Consensus Recommendations to Improve Protocols 2 and 3 for Defining Stream Restoration Pollutant Removal Credits

October 8, 2020

Prepared by:
David Wood and Tom Schueler, Chesapeake Stormwater Network

Appendix I. Response to Comments

Figure 2. Floodplain Restoration by Raising the Stream Bed (Courtesy: Joe Berg, Biohabitats)

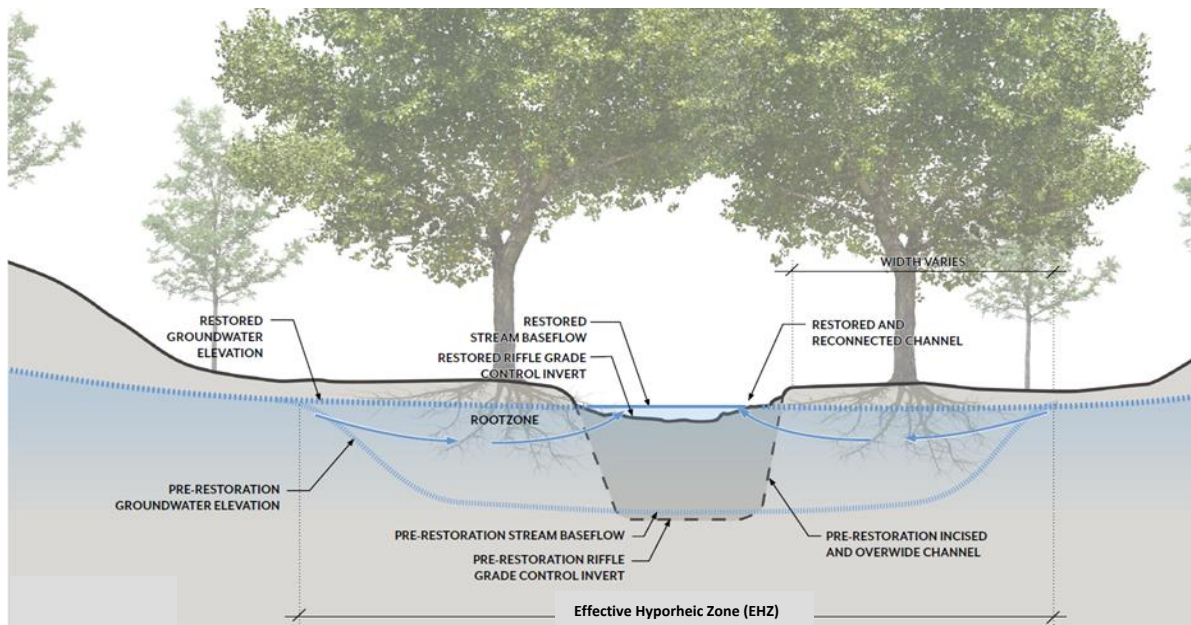
In addition, Figures 2 and 3 do not clearly illustrate these differences. Labels that reflect the narrative descriptions, including the 18 inch criteria, would provide greater understanding.

4. **Figure 2** is a poor sketch because it's not clear or well labeled.

Figure 3. Depiction of EHZ boundaries cross-section and plan view

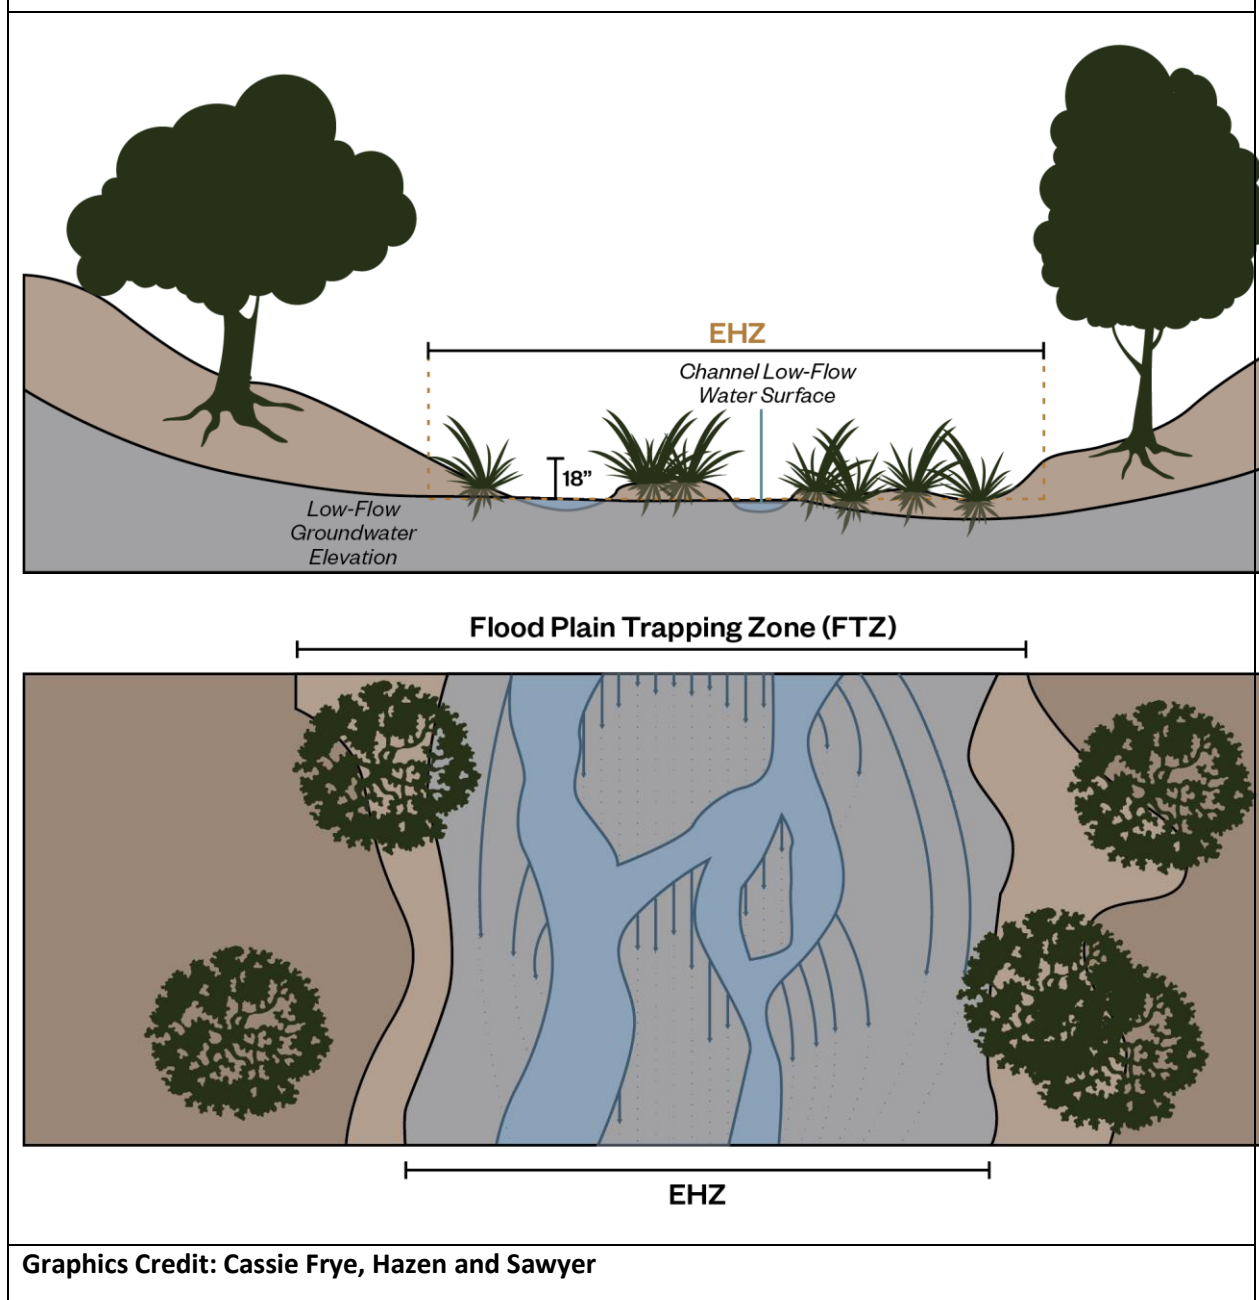
17. In Figure 3, please consider using a detail that does not have the name of a specific practitioner. This affords the specific practitioner a competitive advantage as the Department will be referring our stakeholders to this document.

2. The definition of the HEZ and EHZ needs further clarification both in the narrative and Figure 3 and how it applies to RSB projects. Please see Figure 3 for further details.

Figure 4. Illustration of site-specific discount factors for Protocol 2 (Courtesy: Jeff Hartranft, PA DEP; and Art Parola, University of Louisville).

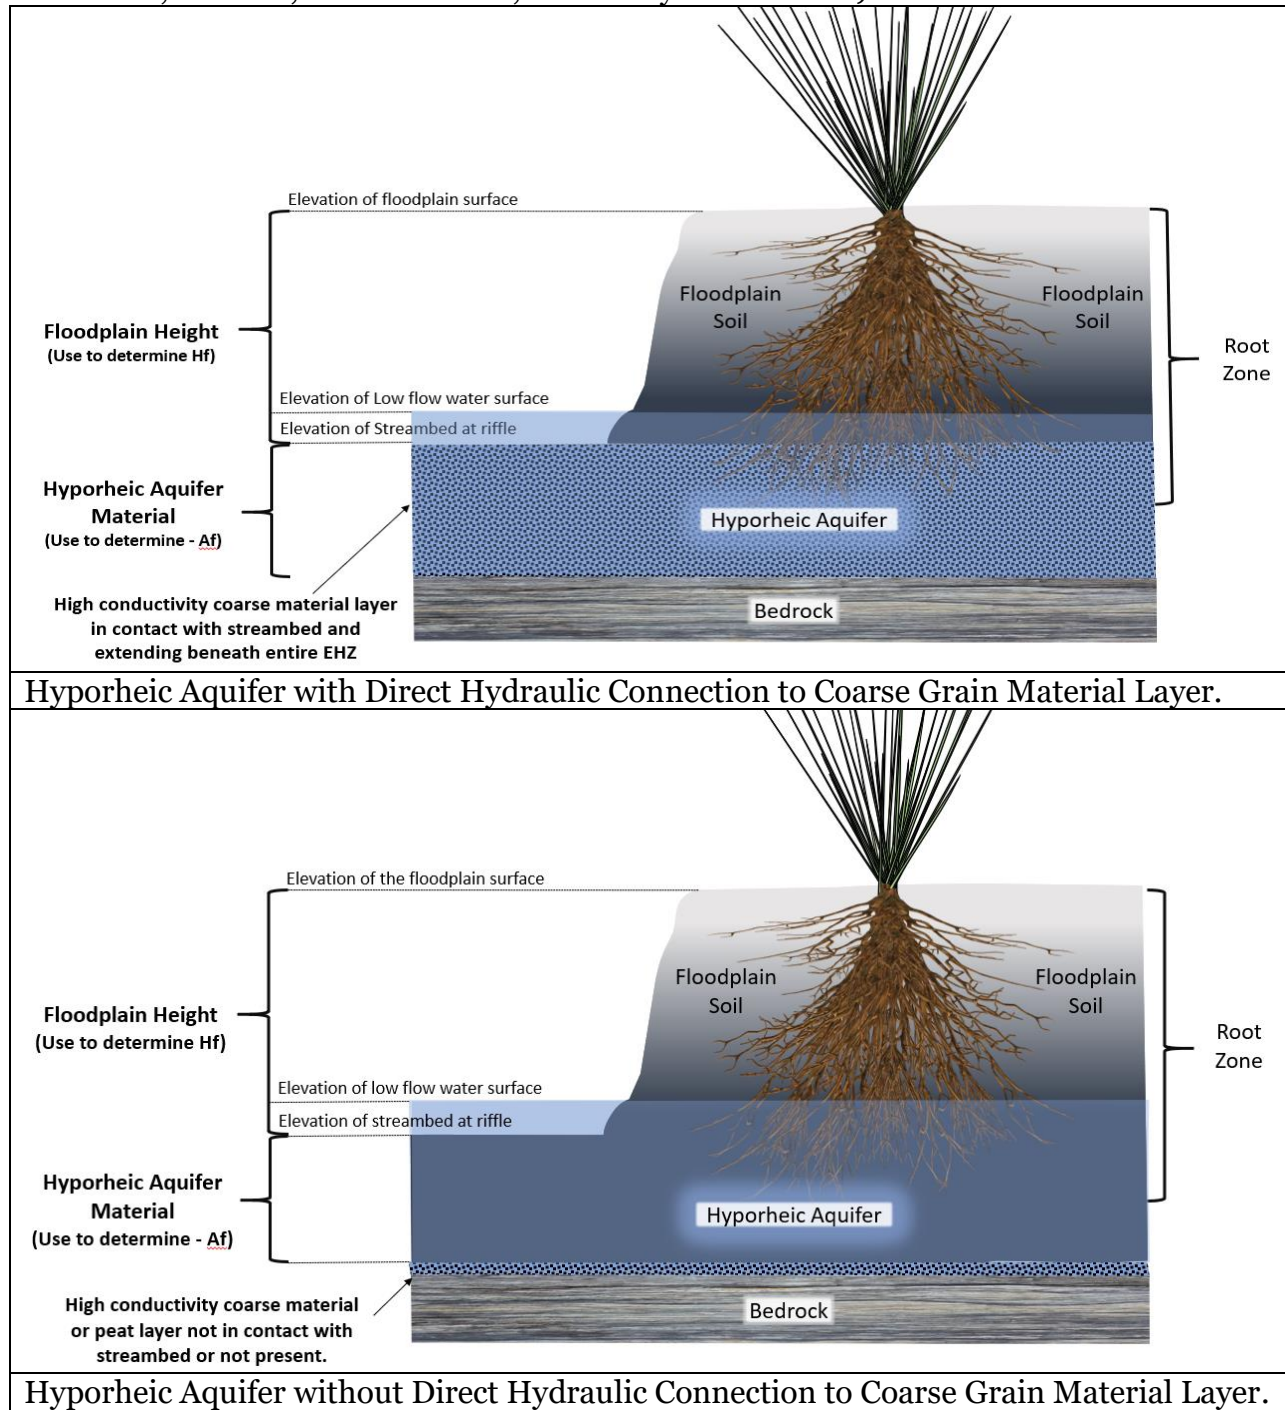
8. Pages 21 and 22: Figures 2, 3 and 4 seem very important yet are not easy to read. Figure 2 is a hybrid of LSR and RSB and contains EHZ and FTZ, but only for LSR, RSB uses old terminology of HB for some reason. Figures 3 has HEZ and EHZ but Figure 4 only specifically labels HEZ. The Text says that EHZ and FTZ are expressed

in Figures 2 and 4 but there's no FTZ in figure 4. Would it be useful to have same type of figure style for both plan view and section view and accurately refer to terms contained in figures in text? In addition, FTZ is only discussed in Protocol 3 - best to have a few robust, complete diagrams to which the two "Protocol" sections refer if possible.
